ADDENDUM NO. ONE (1)
ILM TERMINAL IMPROVEMENTS
CONTRACT 3

Date: July 12, 2019

RE: ILM Terminal Improvements Contract 3

From: The Wilson Group
PO Box 5510
Charlotte, NC 28299

A2-121

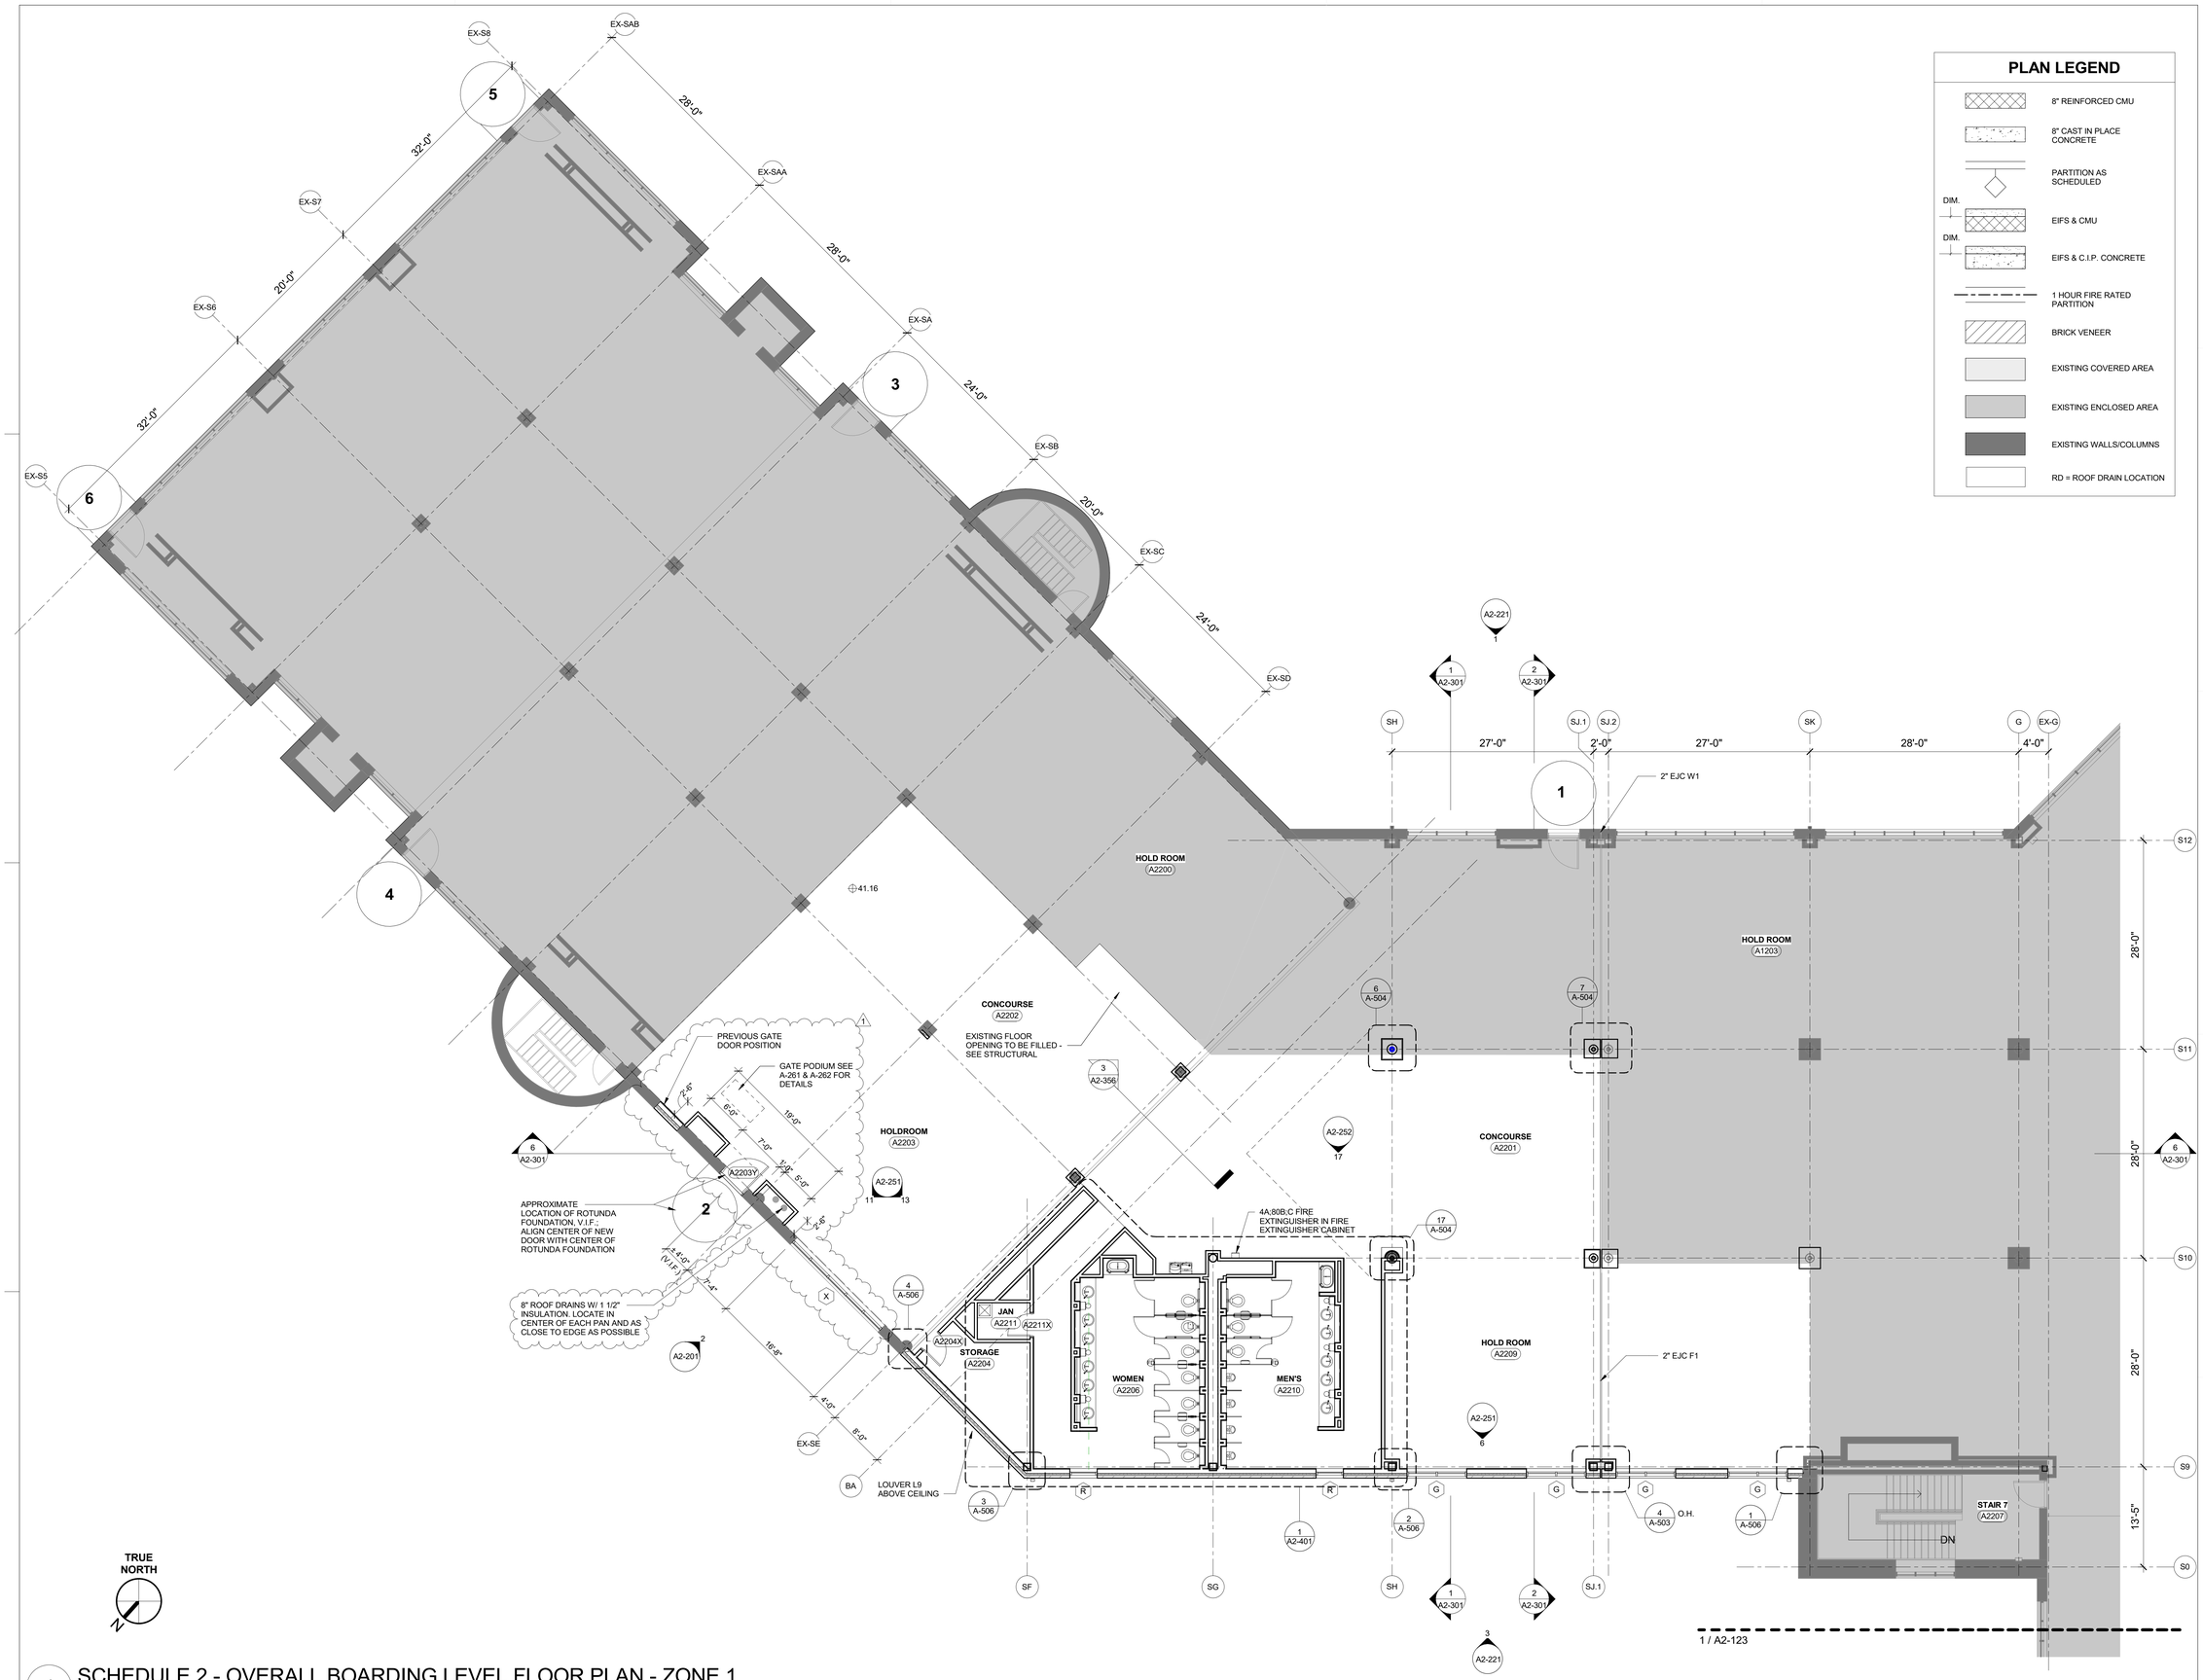
uu. A2-115 – SCHEDULE 2 RAMP LEVEL FLOOR PLAN ZONE 5 (AD-01). *Note: Showing louvers.*
vv. A2-121 – SCHEDULE 2 BOARDING LEVEL FLOOR PLAN ZONE 1 (AD-01). *Note: Modified Gate 2 to incorporate roof drain enclosure.*
ww. A2-143 – SCHEDULE 2 ROOF LEVEL PLAN ZONE 3 (AD-01). *Note: All roof insulation tapered where noted.*
xx. A2-161 – SCHEDULE 2 BOARDING LEVEL RCP ZONE 1 (AD-01). *Note: Modified Gate 2 to incorporate roof drain enclosure.*
yy. A2-201 – SCHEDULE 2 BUILDING ELEVATIONS (AD-01). *Note: Showing louvers and modified window at Gate 2.*
zz. A2-221 – SCHEDULE 2 BUILDING ELEVATIONS (AD-01). *Note: Showing louvers.*
aaa. A2-222 – SCHEDULE 2 BUILDING ELEVATIONS (AD-01). *Note: Showing louvers.*
bbb. A2-251 – SCHEDULE 2 INTERIOR ELEVATIONS (AD-01). *Note: Showing TVs & removed data from gate signage.*
ccc. A2-252 – SCHEDULE 2 INTERIOR ELEVATIONS (AD-01). *Note: Note: Showing louvers.*
ddd. A2-255 – SCHEDULE 2 INTERIOR ELEVATIONS (AD-01). *Note: Note: Showing louvers.*

SHEET NUMBER
A2-302

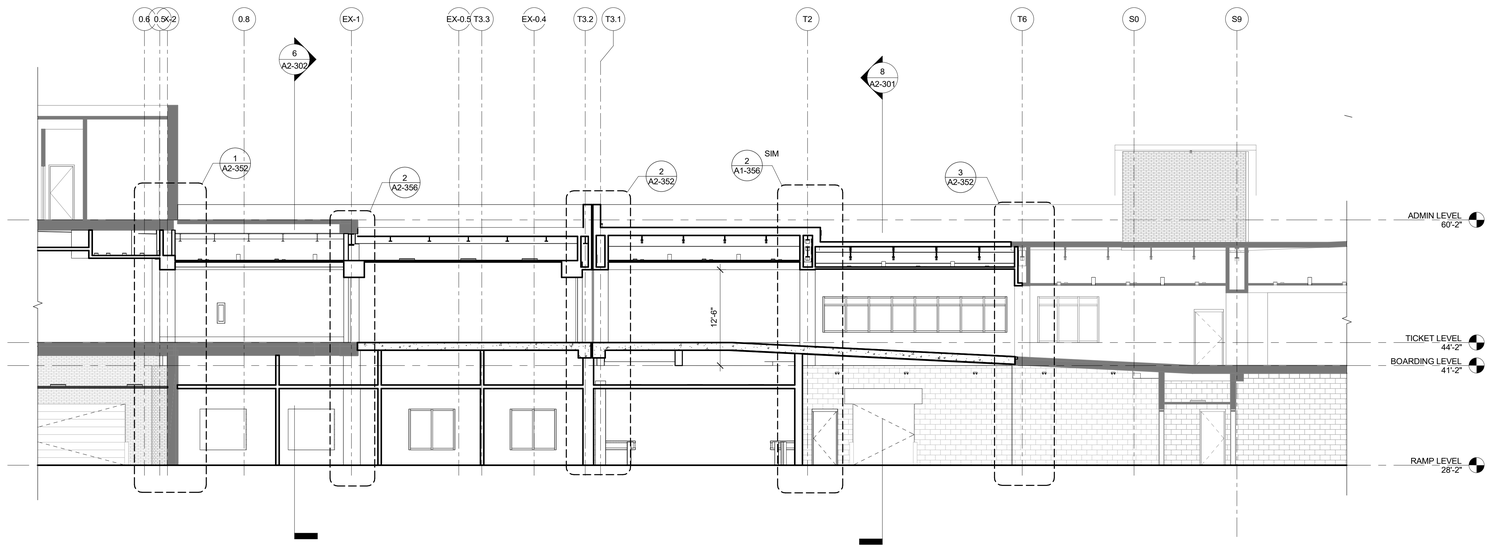
eee. A2-302 – SCHEDULE 2 BUILDING SECTIONS (AD-01). *Note: Modified detail at existing & new roof condition.*
fff. A2-354 – SCHEDULE 2 WALL SECTIONS (AD-01). *Note: Modified detail at existing & new roof condition.*
ggg. A2-404 – SCHEDULE 2 ENLARGED FLOOR PLANS (AD-01). *Note: Showing louvers.*
hhh. A2-731 – SCHEDULE 2 BOARDING LEVEL FLOOR PLAN (AD-01). *Note: Modified seating at Gate 2.*
iii. A-503 – PLAN DETAILS (AD-01). *Note: Modified plan detail notes.*
jjj. A-505 – PLAN DETAILS (AD-01). *Note: Added details at signage.*
kkk. A-514 – SECTION DETAILS (AD-01). *Note: Modified detail at existing & new roof condition.*
lll. A-611 – WINDOW SCHEDULES (AD-01). *Note: Modified detail at existing & new roof condition.*
mmm. A-654 – WALL BASE, WALL AND PANEL REVEAL DETAILS (AD-01). *Note: Added details at gate portals.*
nnn. F1-112 – SCHEDULE 1 – BOARDING LEVEL PLAN ZONE 2 FIRE PROTECTION (AD-01)
ooo. F1-115 – SCHEDULE 1 RAMP LEVEL PLAN ZONE 5 FIRE PROTECTION (AD-01)
